**ENGINEERING CHANGE NOTICE**

Originator:	SHARAN GADE	Date:	Document Number
	Phone No. (416) 754-3322	May 6, 2022	ECN20220506-00
Email Address:	<a href="mailto:Sgade@edac.net">Sgade@edac.net</a>	Revision Number	SHEET
Department	ENGINEERING	1	1 of 1

End of Life for 726 Series connectors and are been replaced with 746 Series. For example: P/N- 726-076-525-201 and has been replaced with P/N- 746-076-525-201.

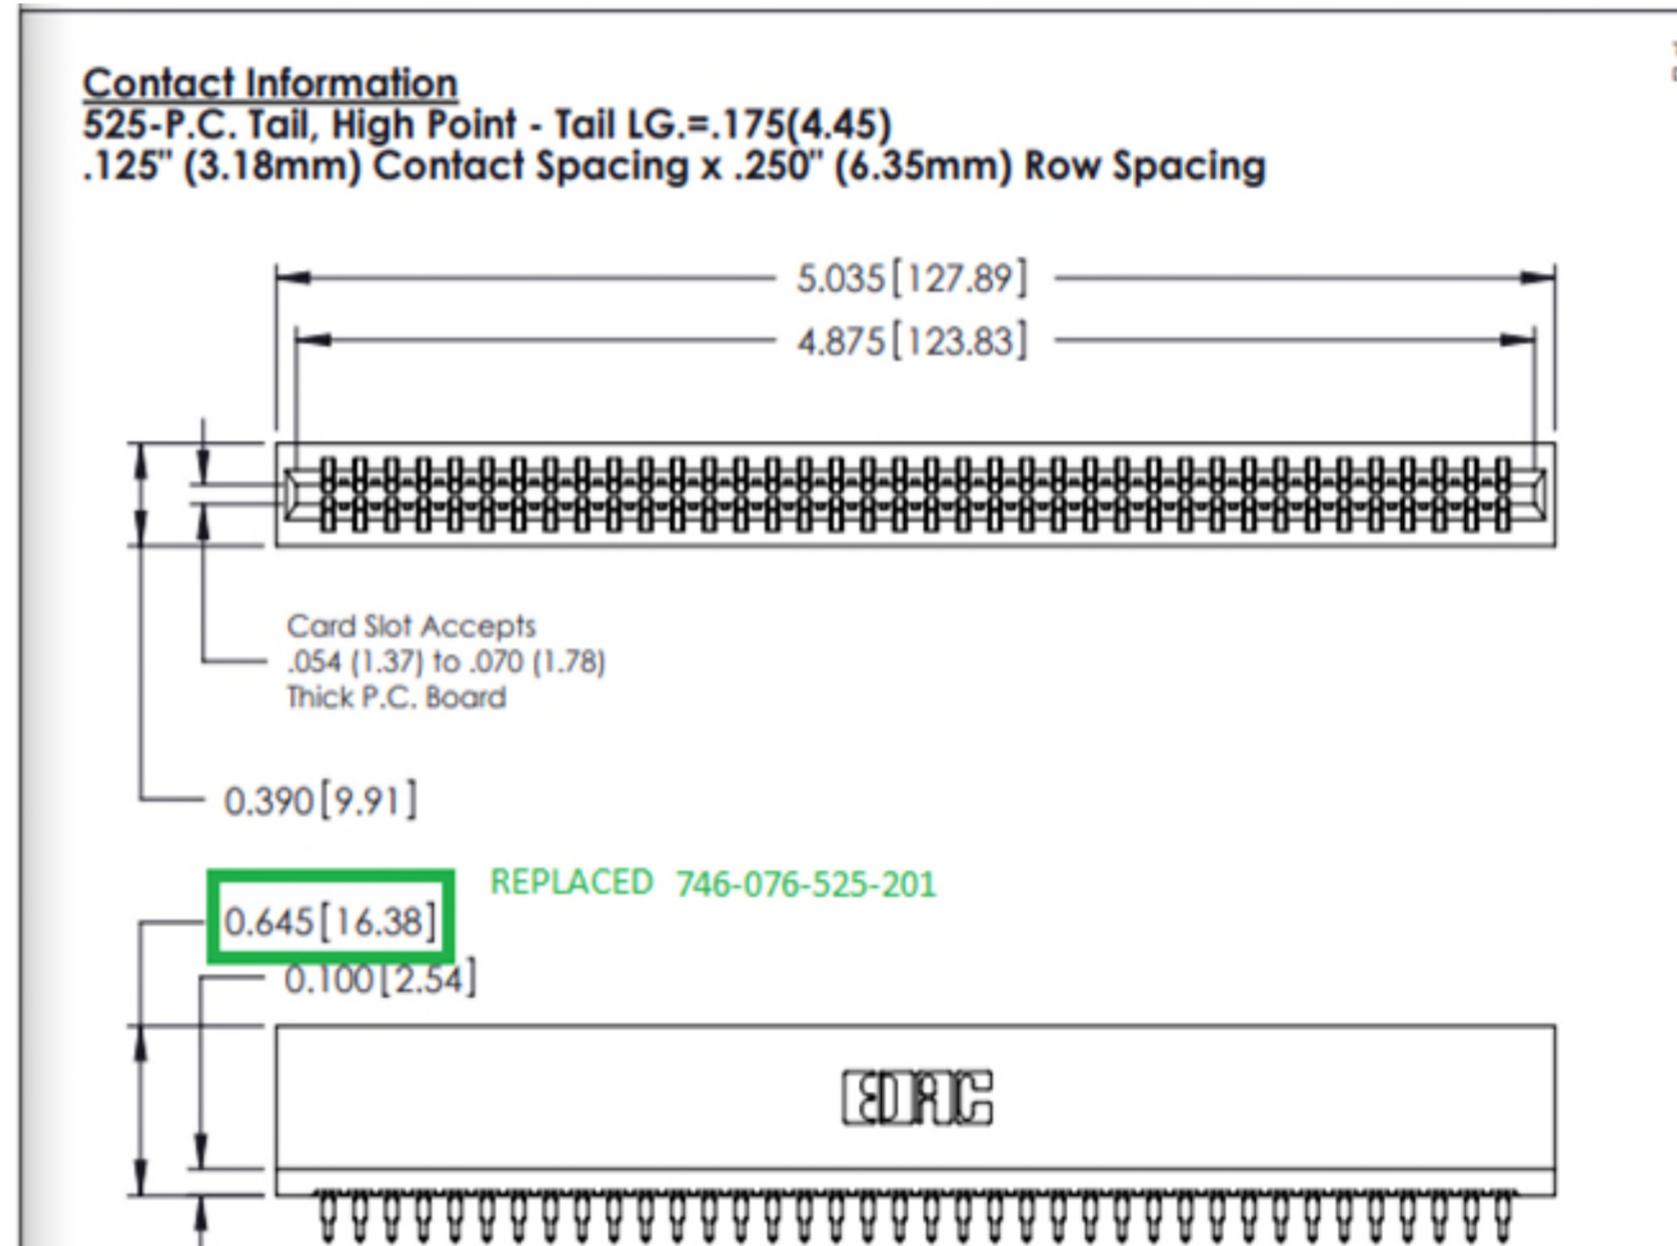
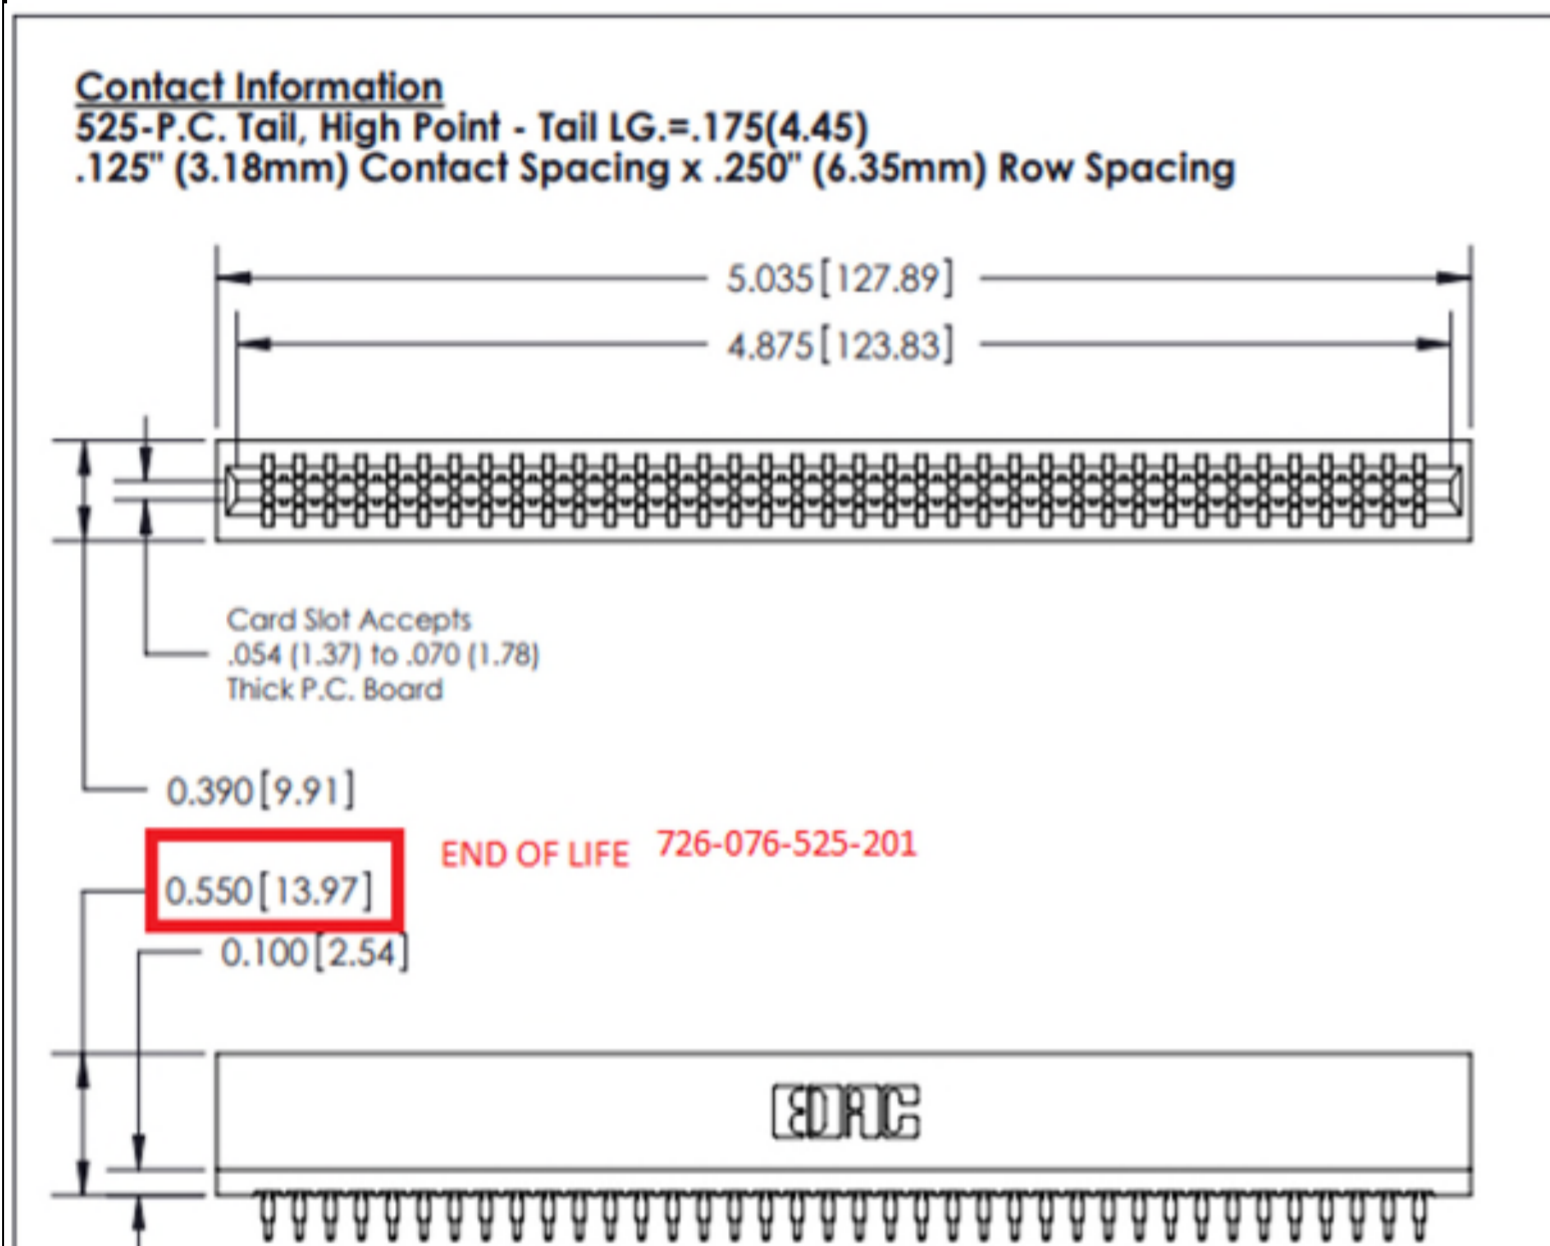
1. Old tooling has worn out and need to be replaced by standard tooling with minimal change in the length of the housing from 13.97mm to 16.38mm.
